SUBJECT: MINUTES OF CRGR MEETING NUMBER 171

Enclosure 1 to the Minutes of CRGR Meeting No. 171  
Proposed Final Revision 3 to Reg. Guide 1.9  
October 11, 1989

**RESOLUTION OF GSI B-56  
DIESEL GENERATOR RELIABILITY**

Figure 1 Graded Response to Degrading EDG Reliability

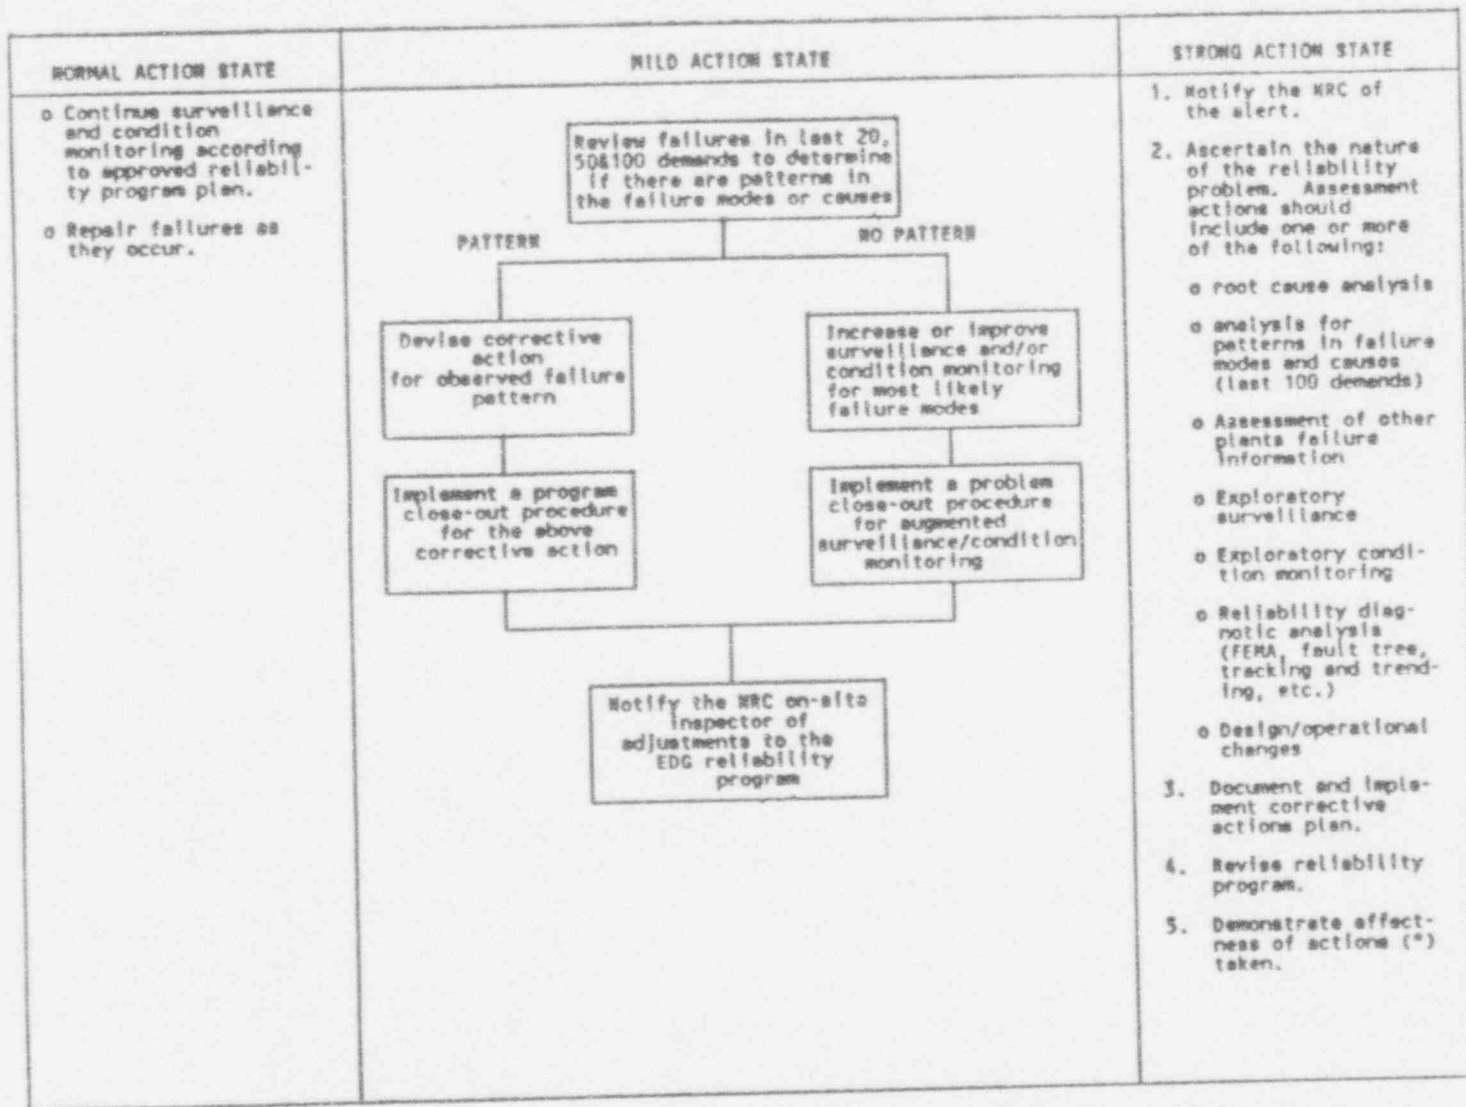
*for problem EDG's*

- o INITIATE MILD ACTION LEVEL (CHANGE SECTION 3.5 AND FIG. 1)
- o REDUCE TEST FREQUENCY FROM MONTHLY TO WEEKLY UNTIL 7 CONSECUTIVE FAILURE FREE START AND LOAD RUN TESTS AS DEFINED IN REGULATORY POSITION C.2.3.3 ARE COMPLETED (CHANGE SECTION 2.3.3 AND 3.5)
- o IF DURING THE CORRECTIVE ACTION TESTING THE EDG EXPERIENCES ADDITIONAL FAILURES, SO THAT THE NUMBER OF FAILURES IN THE LAST 20 DEMANDS IS FIVE OR MORE, CONSIDERATION SHOULD BE GIVEN TO UNDERTAKING A MAJOR OVERHAUL IN ACCORDANCE WITH THE MANUFACTURER'S RECOMMENDATIONS (CHANGE SECTION 3.5)
- o FOLLOWING MAJOR OVERHAUL AND PRIOR TO RETURNING THE EDG TO SERVICE, A SERIES OF 14 CONSECUTIVE FAILURE FREE START AND LOAD RUN TESTS SHOULD BE CONDUCTED (CHANGE SECTION 3.5)

Figure 1 Graded Response to Degrading EDG Reliability

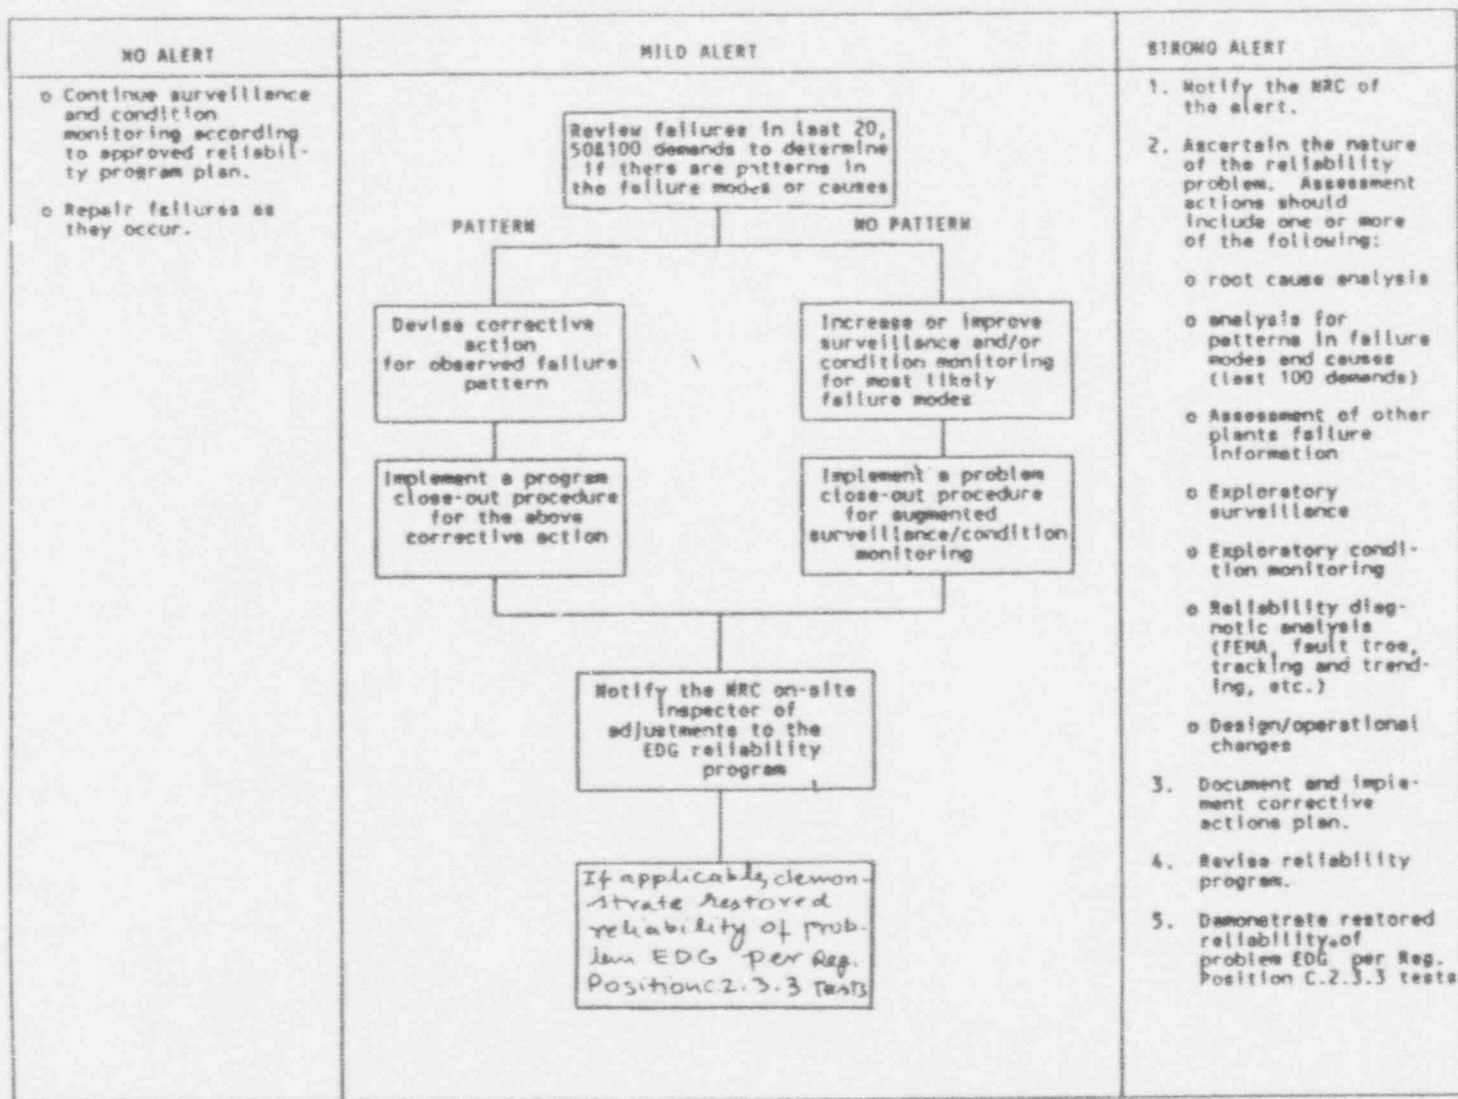
If any individual EDG experiences three or more failures in the last 20 demands, then a Mild Alert is declared and actions in Figure 1 are undertaken including the corrective action testing per Regulatory Position 2.3.3. If during the corrective action testing, the EDG experiences additional failures, so that the number of failures in the last 20 demands is five or more (including the previous three failures), consideration should be given to undertaking a major overhaul in accordance with the manufacturer's recommendations for such failures. If the overhaul necessitates the tear-down and overhaul of the diesel engine, then prior to returning the EDG to service, a series of 14 consecutive failure free start and load-run tests (per Regulatory Position 2.2.3) should be conducted. Regular EDG surveillance testing should then commence. Also, any failures which occurred prior to the 14 consecutive successful tests should not be counted for any subsequent determination of the 3/20 failures criterion of this position.
